Addendum

SPRINGS AT FREMAUX TOWN CENTER
SLIDELL, LA

DRAWING TITLE FIRST FLOOR PLAN - CLUBHOUSE

1 ROOF FRAMING PLAN - CLUBHOUSE
SCALE: 1/4"=1'-0"

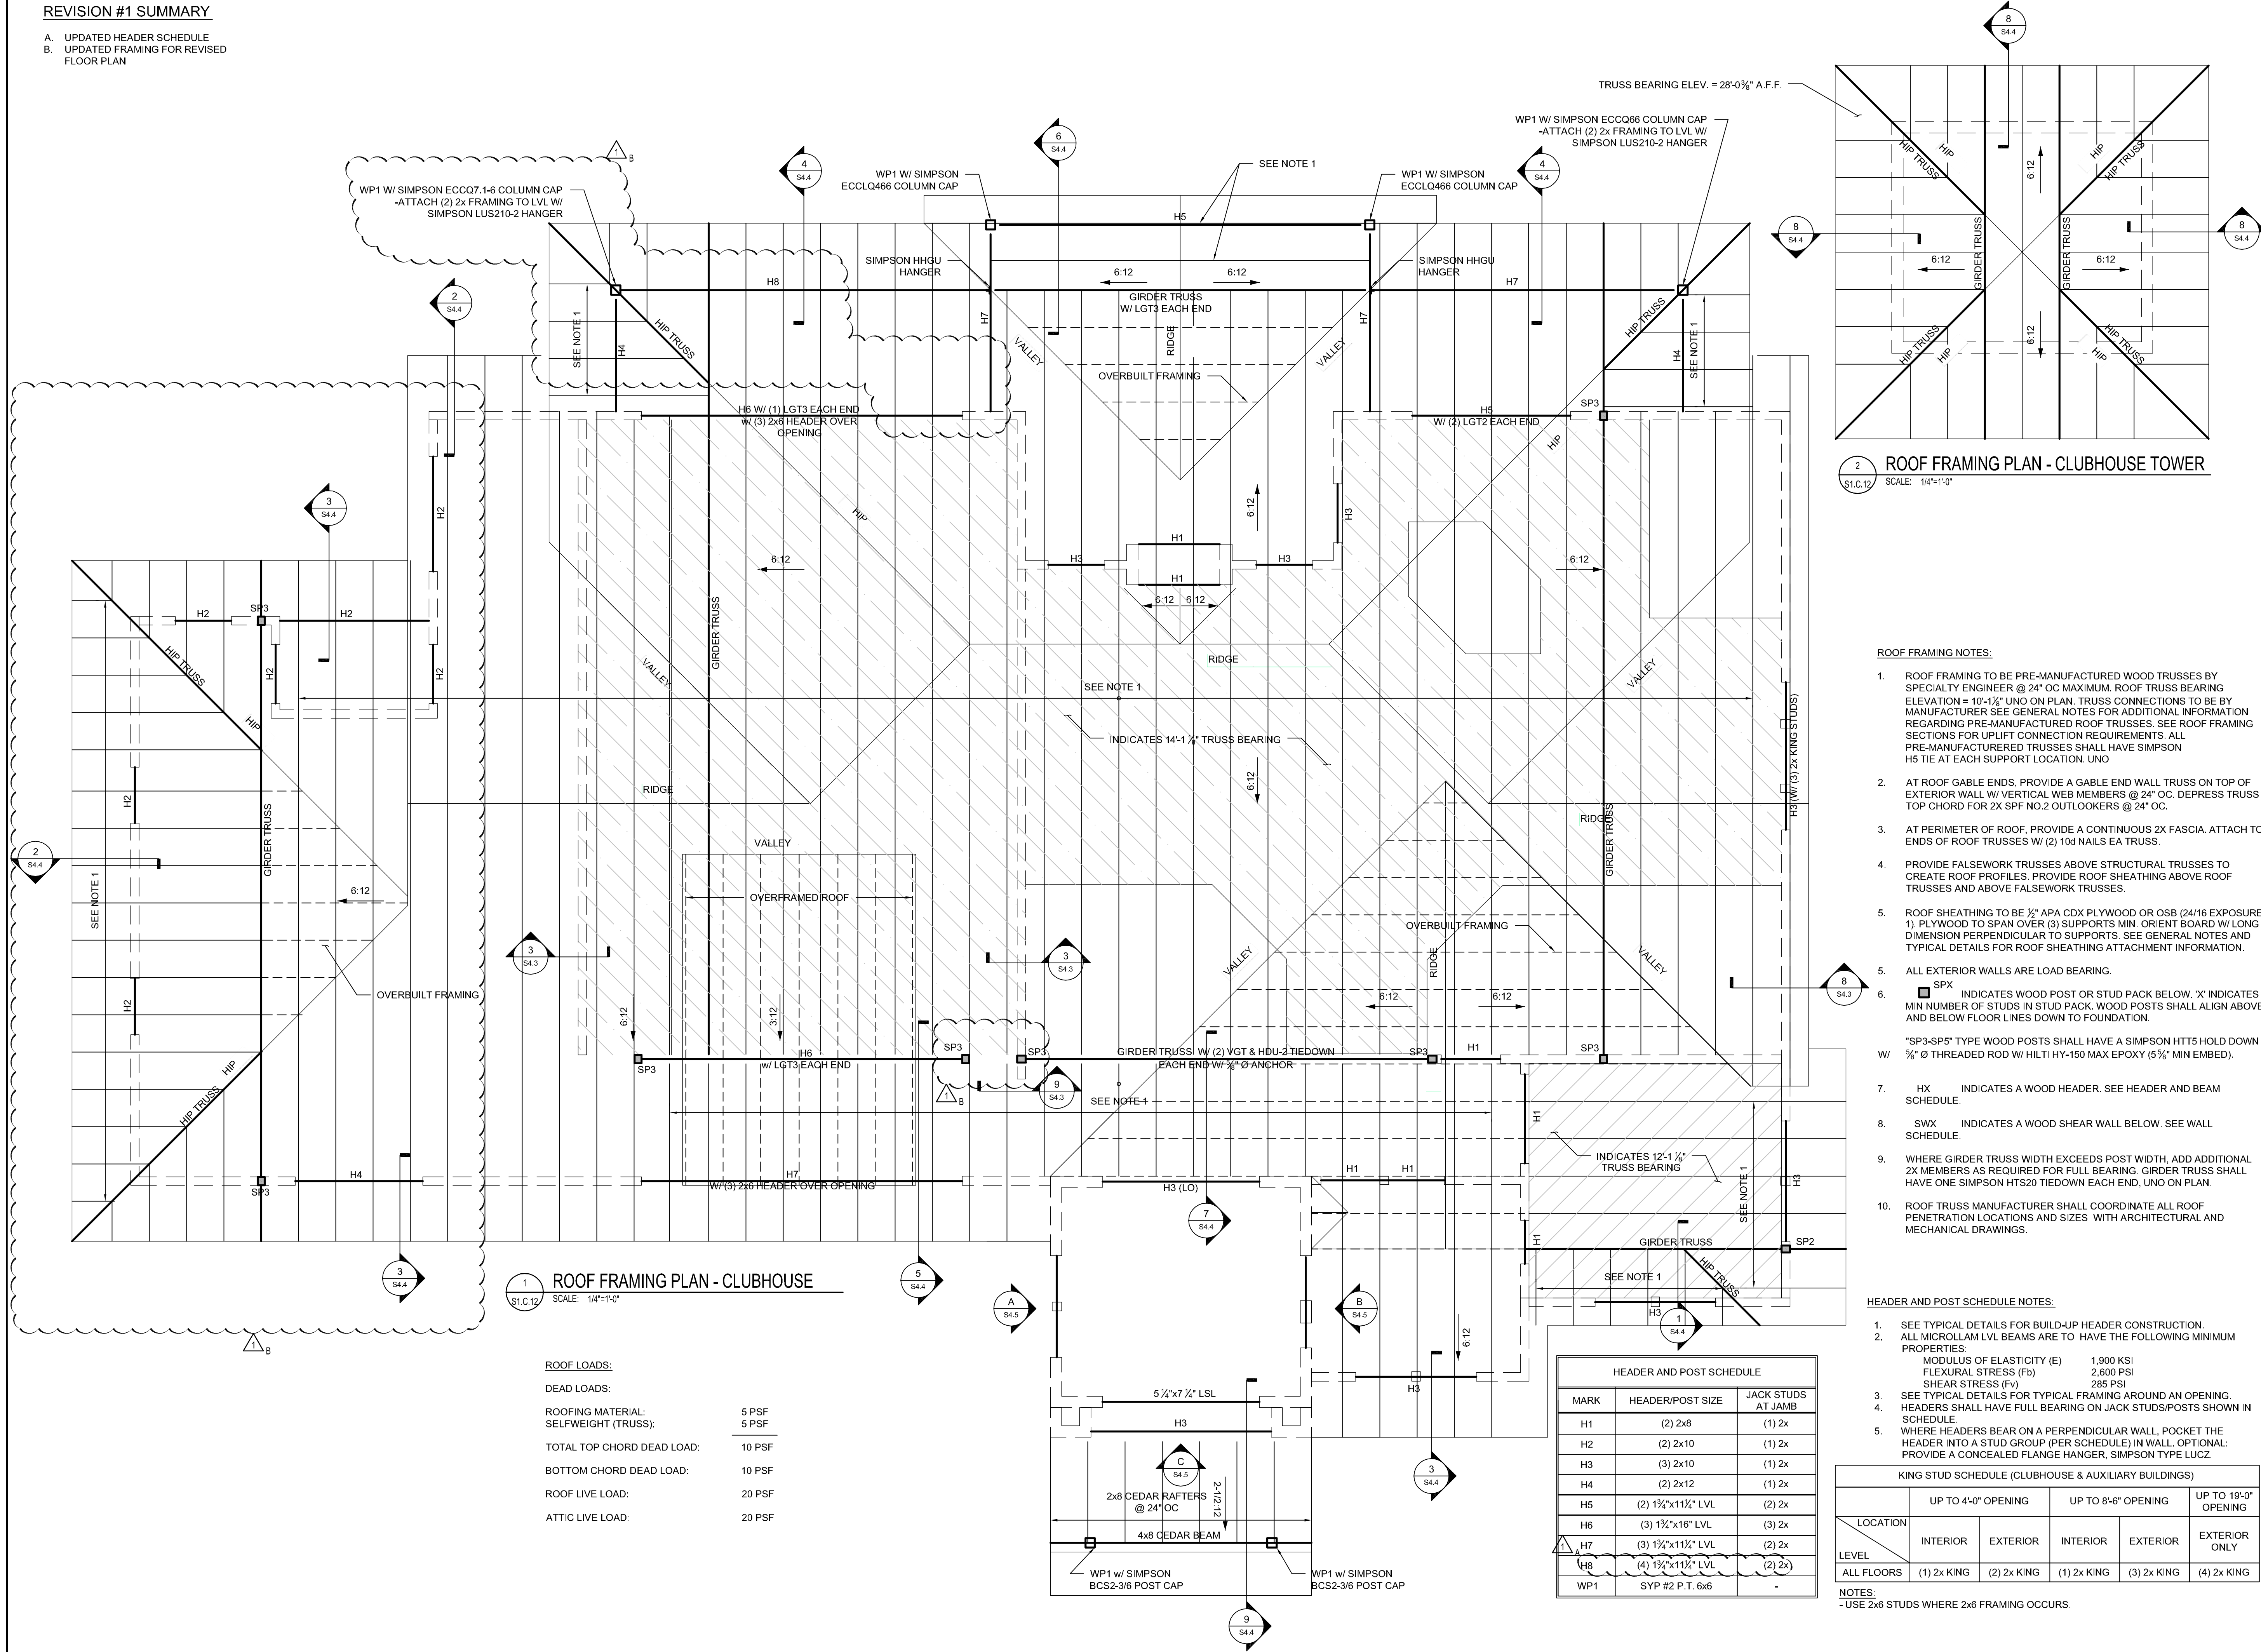
- A. UPDATED HEADER SCHEDULE
- B. UPDATED FRAMING FOR REVISED FLOOR PLAN
